MISSISSIPPI DEPARTMENT OF ENVIRONMENTAL QUALITY

Re: Amended Response to Comments for 2025 Annual Monitoring Network Plan

RE: CCC Comments for AMNP

Seasonal Windroses at Pascagoula 2019–2023

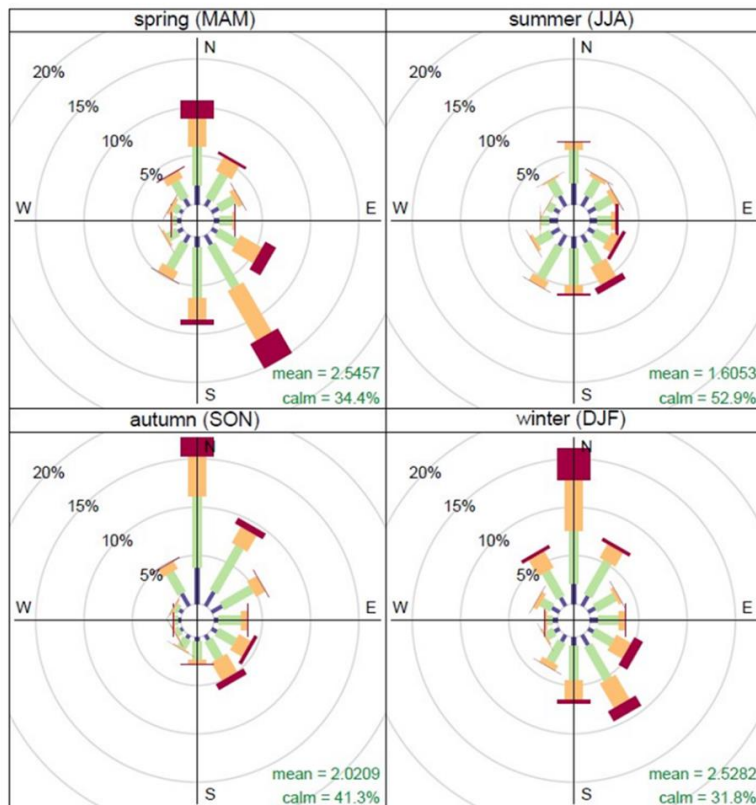
Will the 1 in 6-day schedule be random or predictable? Will there be efforts to avoid periods of active rain when pollutants are washed out of the atmosphere? What will ensure that enough samples are taken when the wind direction is from industry? Is there environmental data at the Cherokee Forest (and other) sites? (winds, temp, RH)? If not, where will this environmental data come from for the analysis?

Both wind direction and weather conditions are criteria that need to be considered when taking these samples in order to gain data that can help us better understand air quality issues for the residents of Cherokee Forest subdivision as this study was designed to do.

In accordance with the methodology outlined in 40 CFR Part 58 (Ambient Air Quality Surveillance) for such periodic sampling, a sample will be collected on every 6th day after monitor start-up at the same time regardless of weather conditions to ensure data consistency. However, equipment has been installed at the Cherokee monitoring station to continuously collect ambient weather data such as temperature, wind direction, and relative humidity.

MDEQ utilized the following historical wind rose data in its evaluation of potential locations for the Cherokee monitoring station [collected from the Trent Lott Airport (KPQL) in Pascagoula, MS].

Based on this information, MDEQ believes that “5303 Ladner Avenue” is the most suitable location to adequately collect data regardless of the seasonal wind direction, given that there is a lack of obstructions (i.e., tree coverage).

Error in the latitude and longitude coordinates

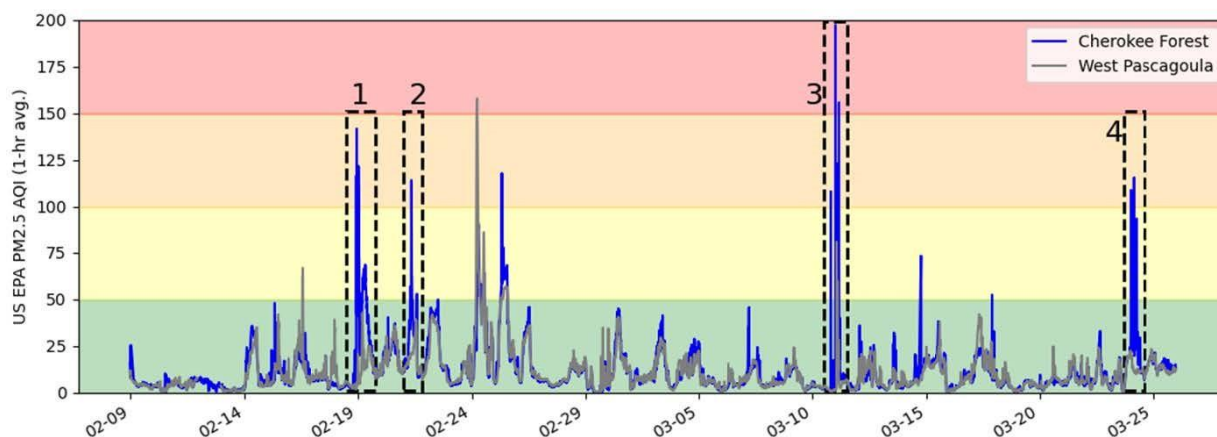
The Latitude and longitude of Cherokee Forest in Table 7 of the Appendix is not correct. It should be 30.3524, 88.5090 instead of 30°35’24”, 88°50’90”.

It appears that this comment stems from a misinterpretation of our formatting. The latitude and longitude of Cherokee monitoring station (as well as the other stations) in Table 7 of the Appendix is to be read as "30.3524, -88.5090" [which equates to 30° 21' 8.6394", -88° 30' 32.4"] instead of "30°35'24", 88°50'90" and has been corrected in the network plan.
